Technical Service Bulletin

No.LA501-
025
25 April
2006

Subject/Concern : Discovery 3/LR3 - Restraint Control Module Diagnostic Trouble Codes (B0070 1B, B0072 1B)

Manually Adjustable Seats

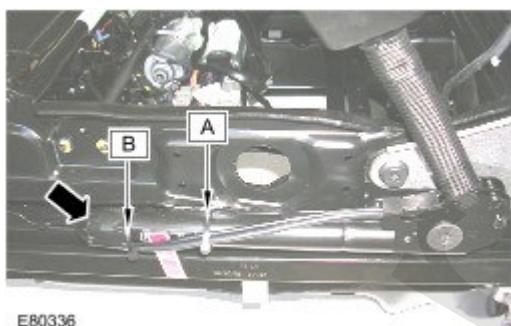
Cause : The under-seat wiring harness of the seatbelt buckle pre-tensioner has been incorrectly routed. The subsequent tight harness run can lead to the above DTC logs when extremes of seat adjustment positions exert strain on the harness connectors.

- 1 . Remove the affected front seat. For additional information, refer to Global Technical Reference (GTR) Discovery 3/LR3 Workshop Manual Section 501-10, Seating, Front Seat (78.10.44/99).
- 2 . Release the pre-tensioner harness and disconnect the connector from the seat frame.
- 3 . Route the pre-tensioner harness around the barrel of the pre-tensioner body as shown.
 - 1 . Secure the harness with a cable tie at point A.
 - 2 . Place a length of suitable black tape around the pre-tensioner body as shown.
 - 3 . Secure the harness with a cable tie at point B.

Cable tie the pre-tensioner harness to the seat frame as shown.
